Project 171.05027.008

RE: Response to Review Comments  
Nordic Aquafarms Inc., Land-based Aquaculture Facility  
Belfast, Maine  
L-28319-26-A-N

This letter provides responses to the Department of Environmental Protection letter from Kevin Martin to Elizabeth Ransom dated July 3, 2019. For clarity, the entire comment from the letter has been copied below and italicized. Responses are in regular text, and on the attached plans and figures as referenced below.

**Belfast Aquaculture Project**  
**Revised Wetland and Stream Survey**  
**Date: August 14, 2019**

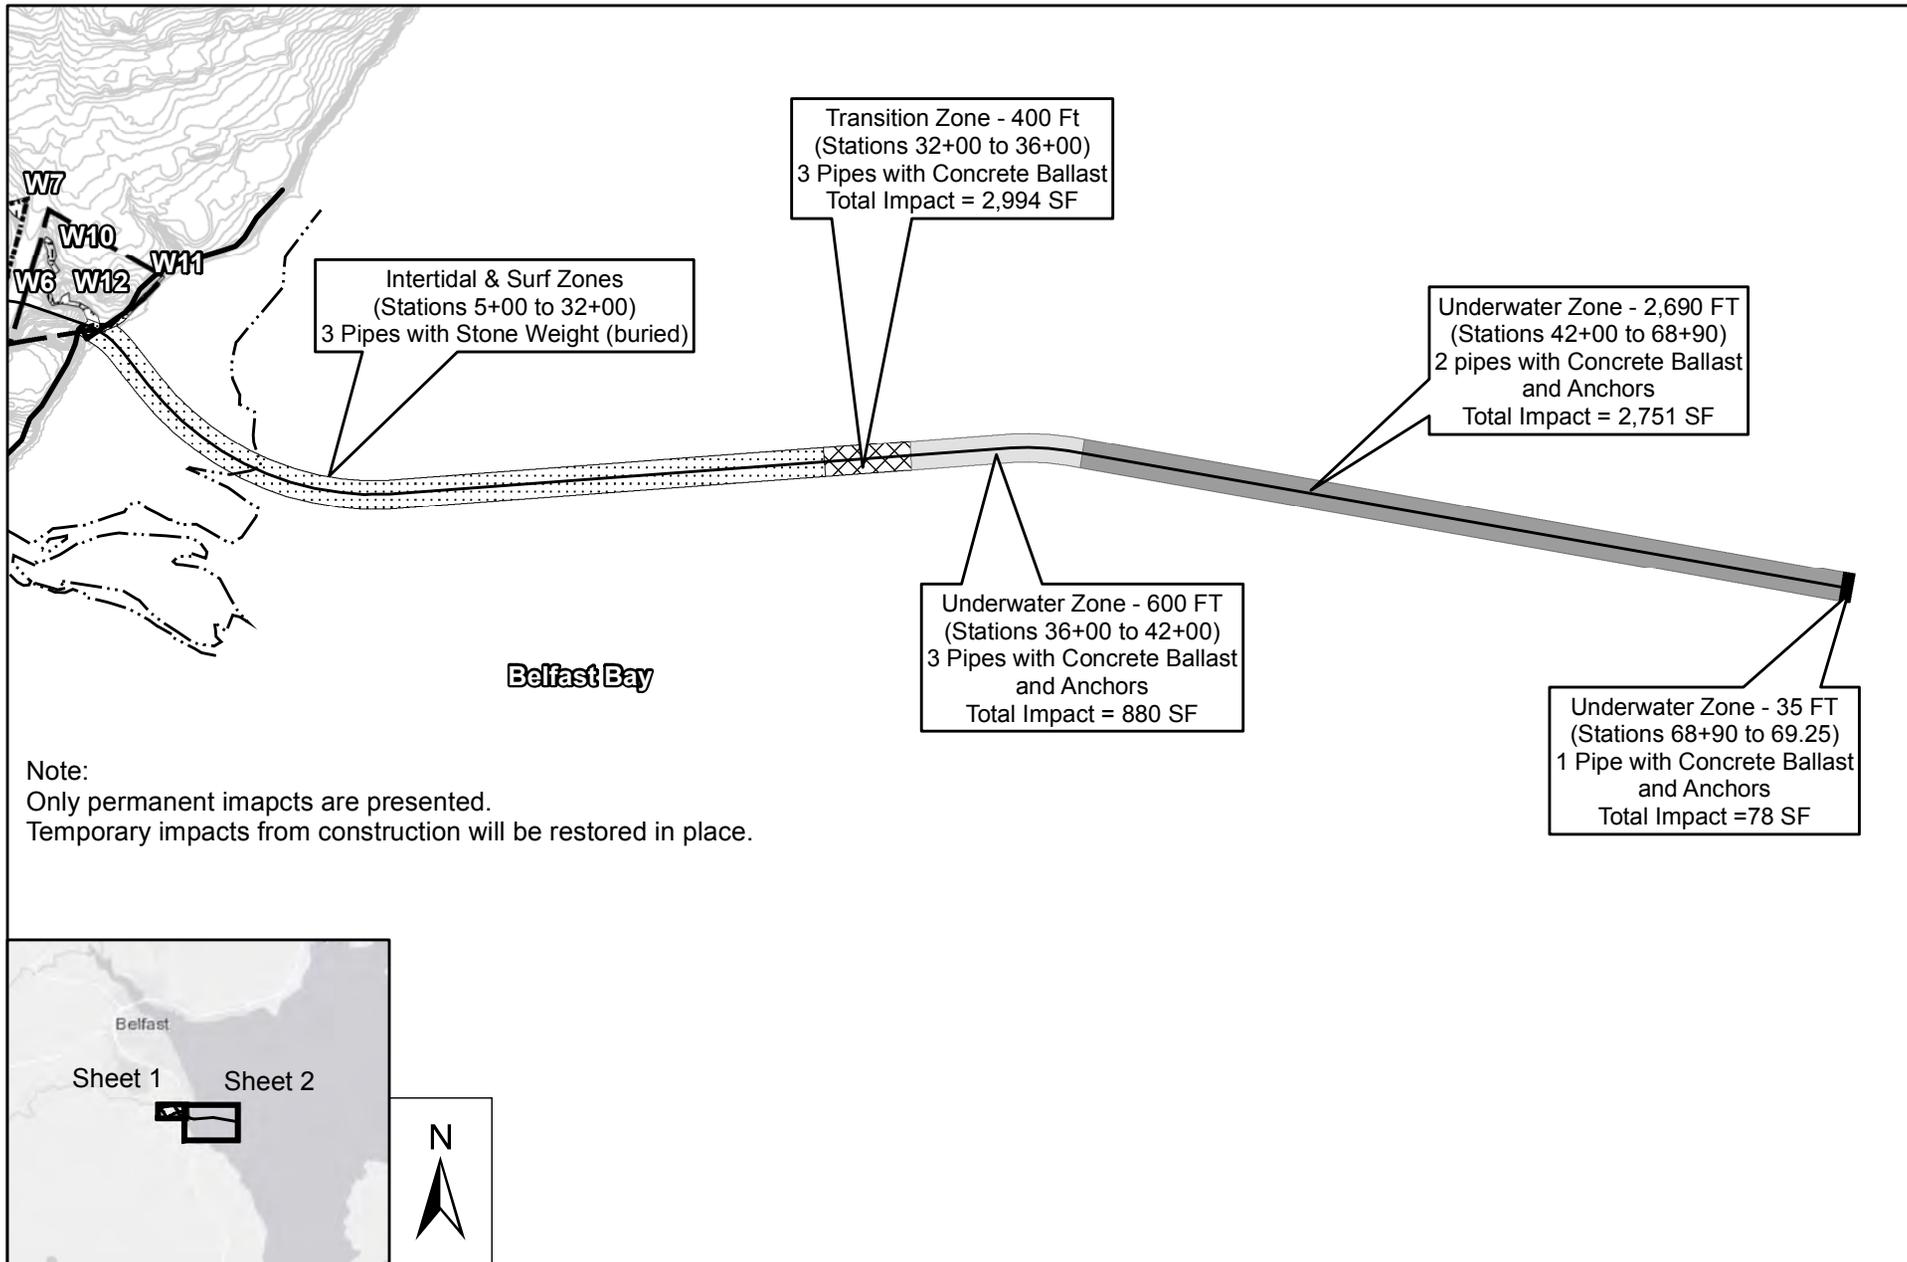
9. *Please submit wetland determination data forms for all on-site wetlands. Only data forms for wetlands W1, W5, W10, and W11 have been included in the NRPA application to date (Attachment 12, Appendix A). In addition, the topography and vegetation observed in Wetland W15 by the Department at its May 17, 2019, site visit indicates that Wetland W15 may be greater in size than originally delineated by the applicant. Please provide any additional information you may have supporting this delineation. Further, observations from the Department's site visit suggest that Wetland W1 is a wet meadow freshwater wetland and a forested freshwater wetland, as compared to the applicant's wetland determination data form for Wetland W1, which states that this wetland is a forested freshwater wetland. Please confirm whether the Wetland W1 data form accurately states the appropriate wetland classification for Wetland W1, and that the location of the Army Corps Data Plot points are correctly depicted on the plan titled "Belfast Aquaculture Project Wetland and Stream Survey," which is found in the natural resources report, titled "Natural Resources Report," prepared by Normandeau Associates and dated May 8, 2019.*

**Data Forms:** Data forms have been compiled and are included in **Attachment H**. The compilation includes forms for W1 and W14 (2 transects, 4 plots to document the wet meadow and forested area, all of which is labeled as W1 on the survey plan, which is explained below), W5, W10, W11 (wetland plot only for W11 as the adjacent area is wetland and documented by the plots completed in W10), W15 and W19. Data forms were initially intended to represent each wetland type encountered (forested, wet meadow, etc.) on each of the three properties delineated. Therefore, forms were not completed for all wetlands.

wetland finger to S10 (W19), are shown on the Revised Wetland and Stream Survey dated July 26, 2019 (**Attachment A**). The data forms for W15, and W19 are also attached (**Attachment H**).

**W1 versus W14:** Wetland delineations occurred over the course of time as additional lands were incorporated into the project site. The first to be delineated was the Water District property. The second was the Eckrote property and the third was the Perkins property. The dates of the delineations are shown on the map titled Revised Wetland and Stream Survey (**Attachment A**). W1 was the first wetland to be delineated on the Water District property on May 3 and 4, 2018. On July 24, 2018 the Eckrote property was delineated and the numbering sequence picked up where we left off at number 10 (W10). When the Perkins property became available the wetlands were delineated on August 27-28, 2018, again picking up the numbers where we left off at number 13 (W13). Once all wetlands were delineated W1 and W14 were determined to be contiguous, were joined, and the number W14 was eliminated with the area becoming part of W1. As noted in the Natural Resources Report dated May 8, 2019 (Page 4, Paragraph 4) W1=W14. Attached (**Attachment H**) is the data form for W14, the plots for which are shown on the Revised Wetland and Stream Survey map in the wet meadow area of W1.

PROJECT MANAGER:	PROJECT NO:	18076
JOB CAPTAIN:		<b>CS501</b>

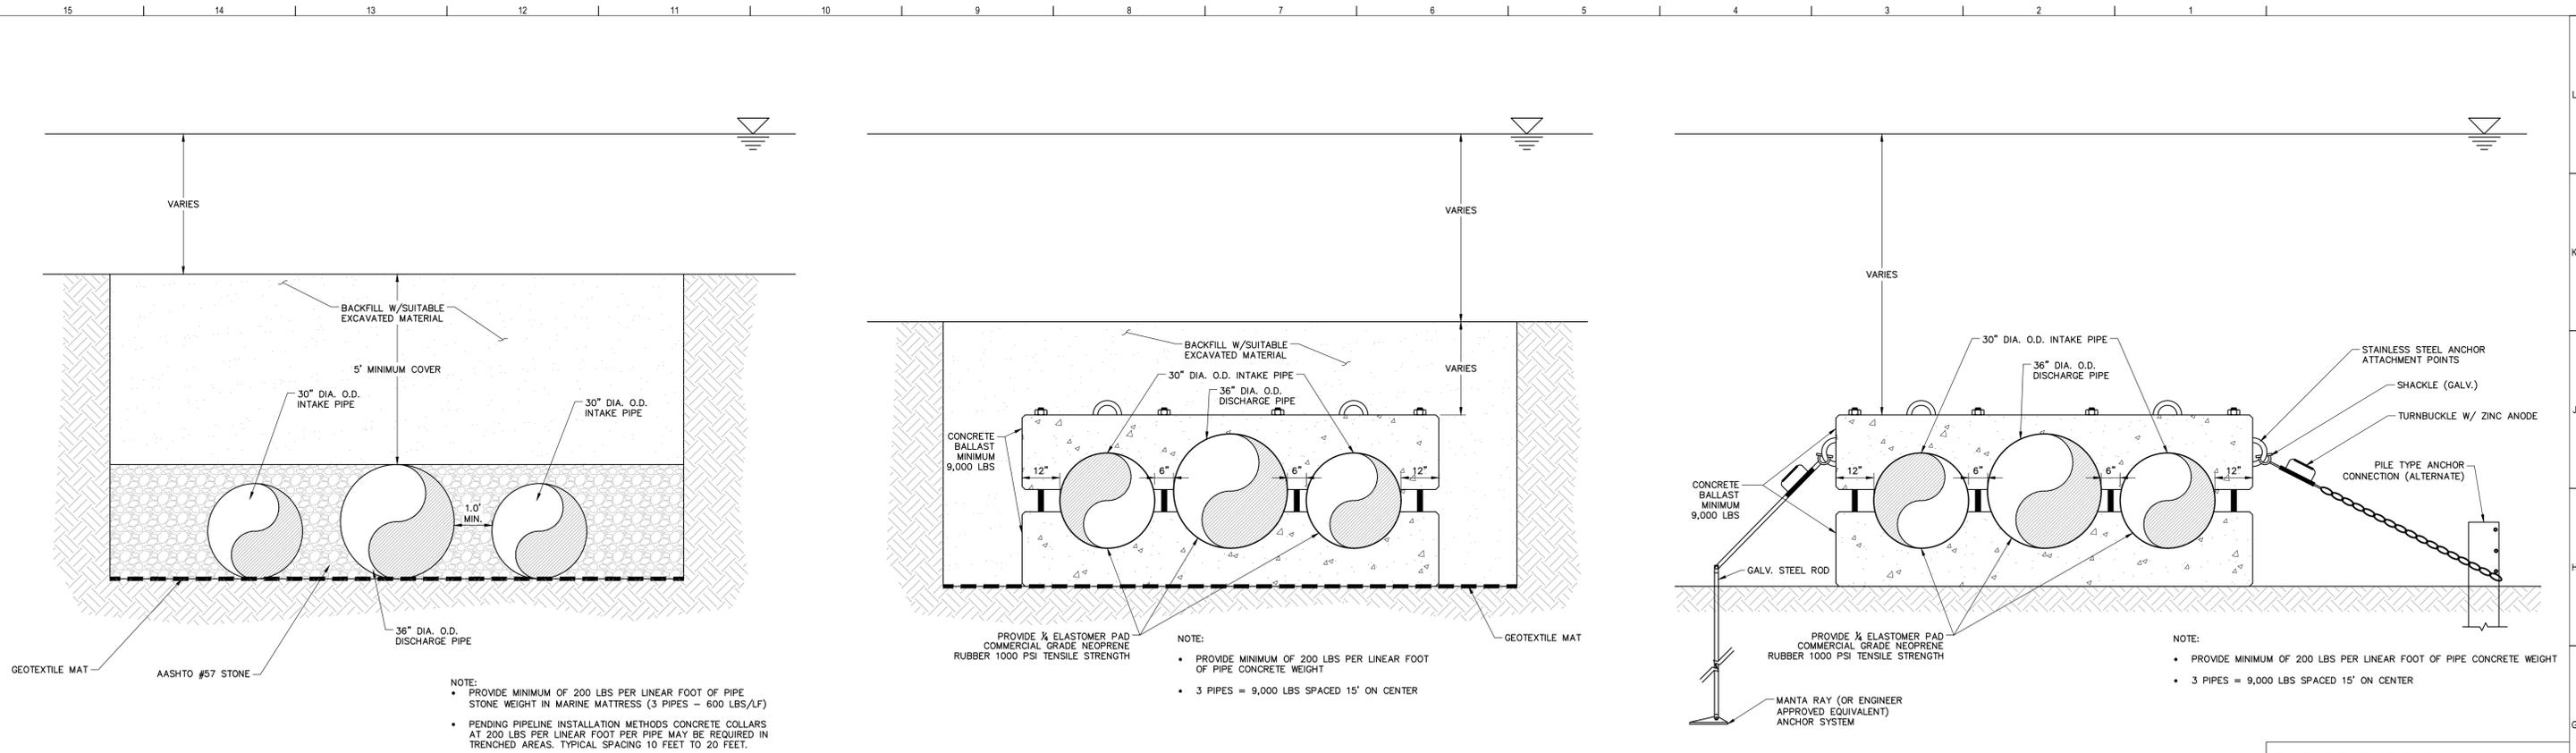
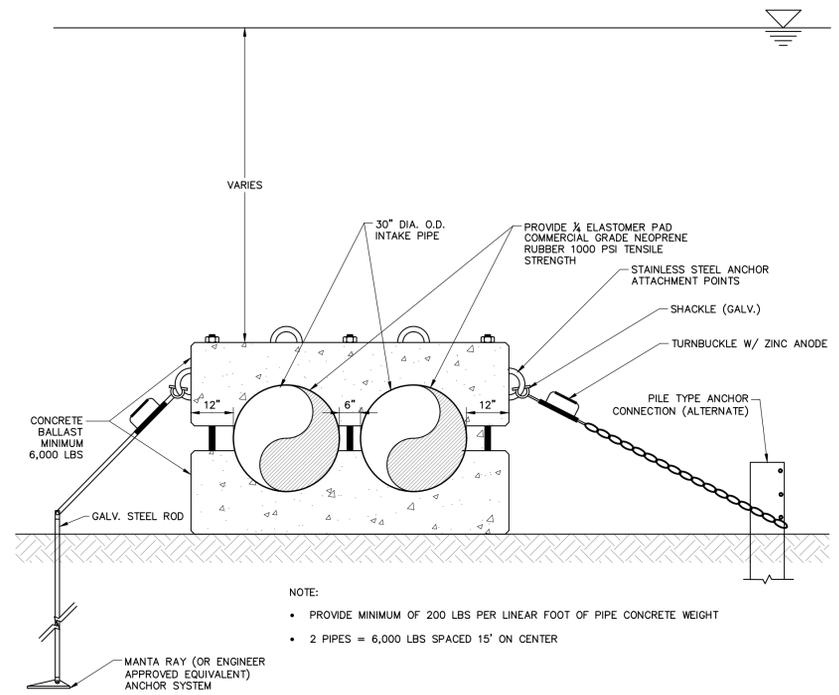
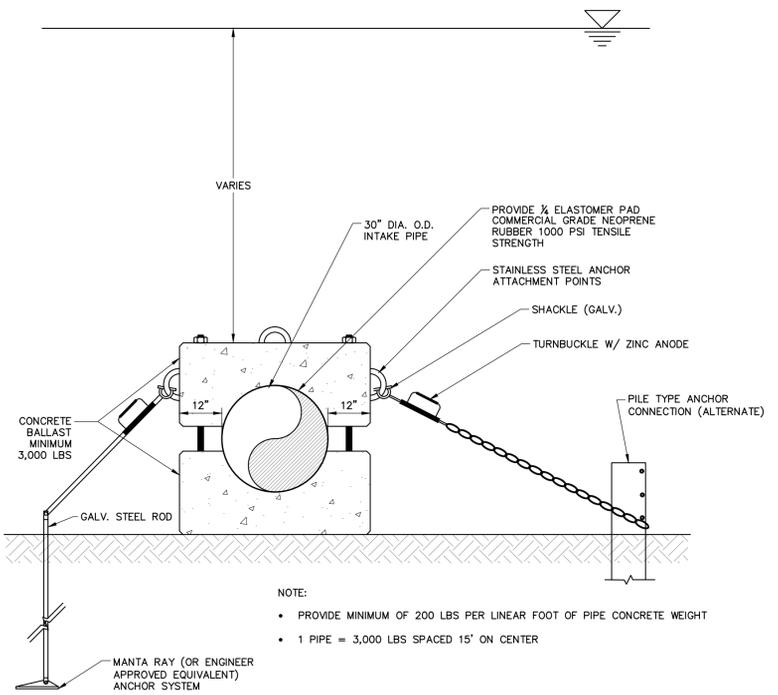
2. For the proposed work associated with coffer dam system installation and placement of the pipe anchors, please provide the square footage of proposed permanent and temporary impact to the coastal wetland and the Tidal Waterfowl and Wading Bird Habitat.

We analyzed the load requirements at 15-foot spacings to determine a weight requirement of 3,000, 6,000 and 9,000 pounds for the one-, two- and three-pipe installations. Based on details on Drawing CS501 (attached), we were able to establish the area of the face of the anchor and calculate a minimum anchor thickness to achieve the load requirements. From there, we determined a standard 2-foot thickness for all anchors will meet the design criteria.

We believe that a combination of 1) concrete anchors and helical anchors or 2) concrete anchors with helical and guide pile anchors would achieve a stable pipeline installation with much less permanent seabed impact. Attached are updated details (Sheet CS501) for your review.

Updated details on attached Sheet CS501 reflect the dimensions and characteristics of the installation. Based on the size and spacing characteristics discussed above, we calculated the permanent impact to be 6,549 SF. See Table 1 below for how we arrived at that number.

**Belfast Aquaculture Project  
Impact Compensation Plan  
Date: August 16, 2019**

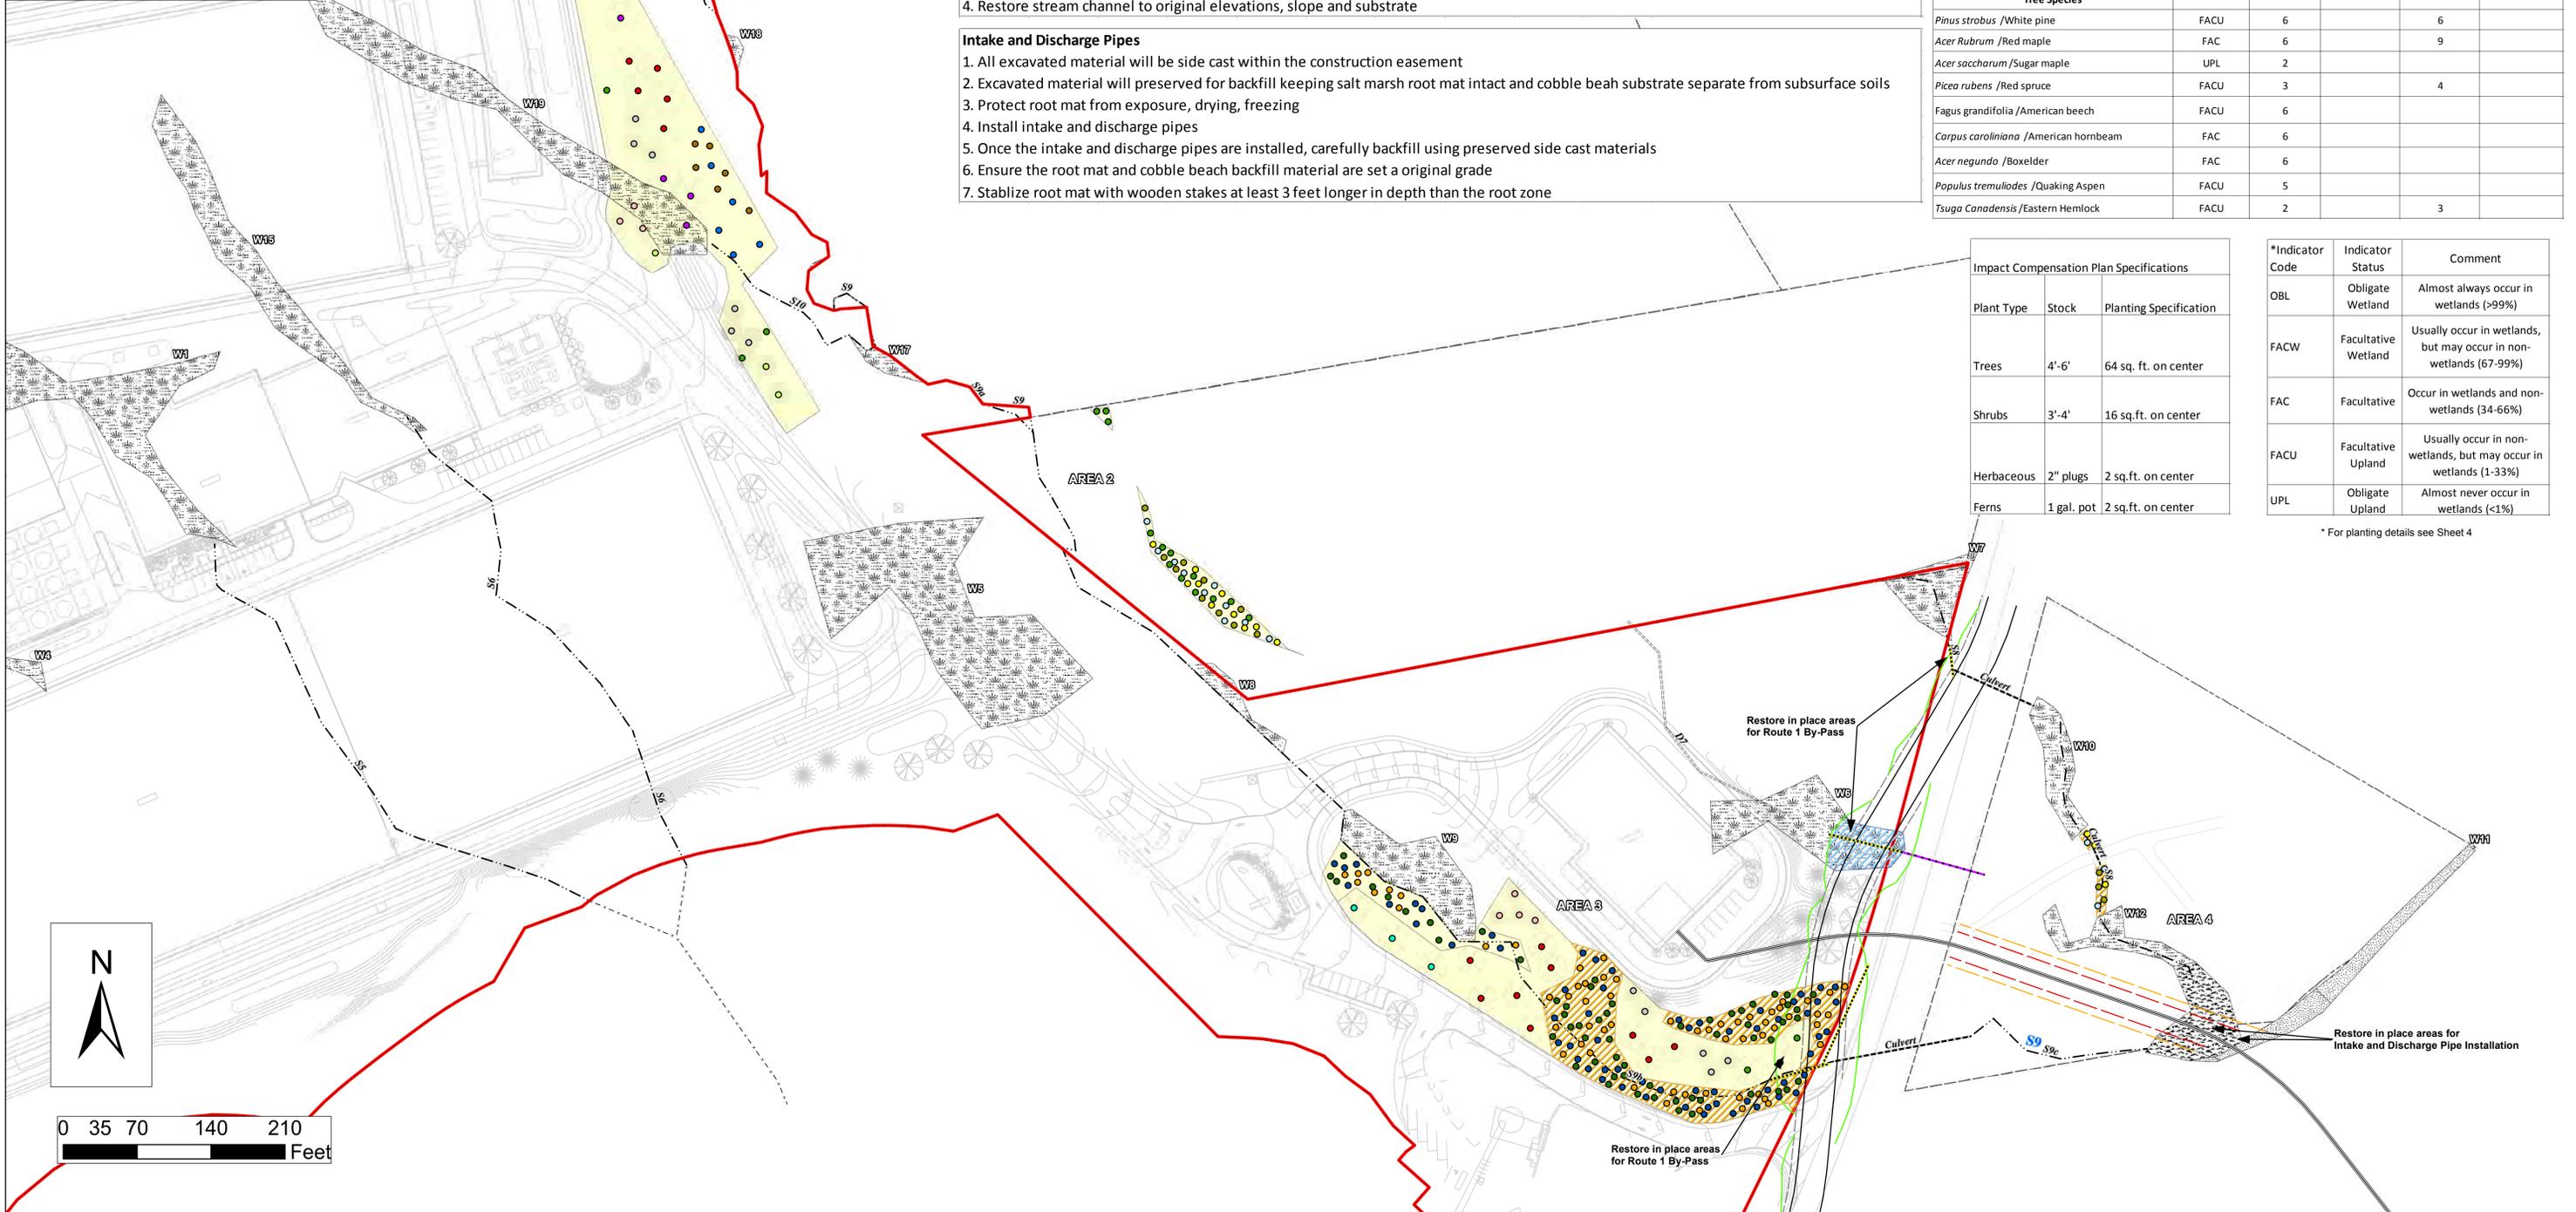
*11. Please provide a separate, more detailed planting plan for the entire length of proposed restoration area at stream S9. The information provided appears to be more of a landscaping plan than a restoration plan.*

The planting plan for the Stream S9 restoration areas has been revised and is attached (**Attachment E**). It includes a set of four sheets: Sheet 1 shows the deeded buffer, Sheet 2 shows the specifications for all aspects of restoration (restore in place impacts and riparian restoration areas) and, Sheet 3 shows cross sections for restore in place areas for the sewer force main and Rte.1 by-pass. Sheet 4 provides details for planting and seeding.

**Belfast Aquaculture Project  
Cross Section Map  
Date: August 16, 2019  
SHEET 3**

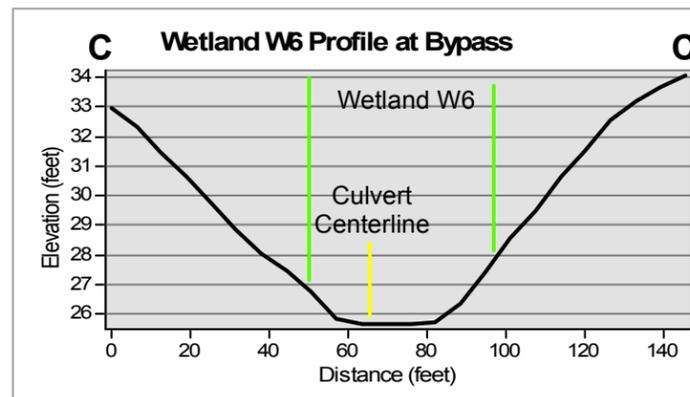
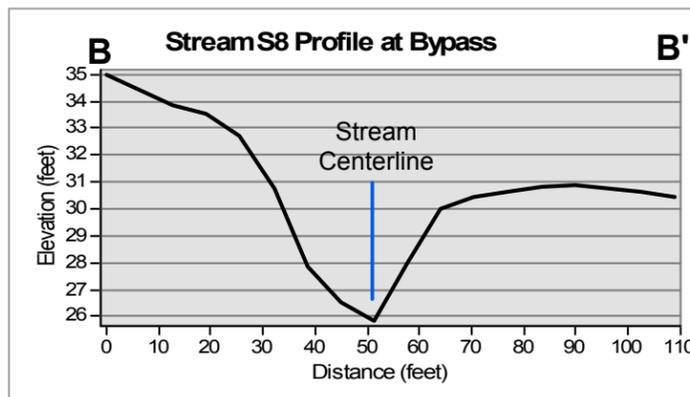
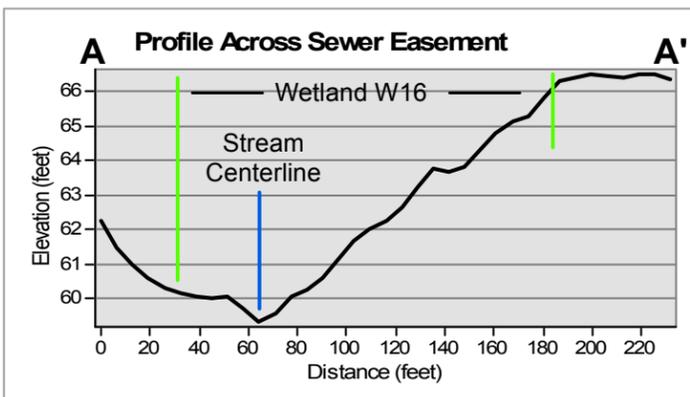
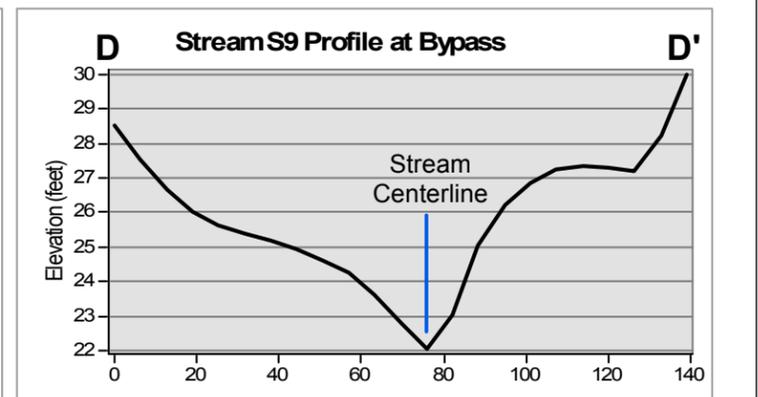
*13. Please submit cross sectional plans that depict all grading changes that are necessary to implement the proposed restoration at stream S9.*

Cross sections of existing conditions at the temporary crossings of S9 have been developed (**Attachment E**, Sheet 3). Cross sections are provided for the sewer crossing of S9 and the Route 1 by-pass crossing of S9. The existing condition cross sections will be used to restore these areas to original grade once the sewer line is installed and the by-pass is removed. Additional grading changes for restoration planting are not planned.
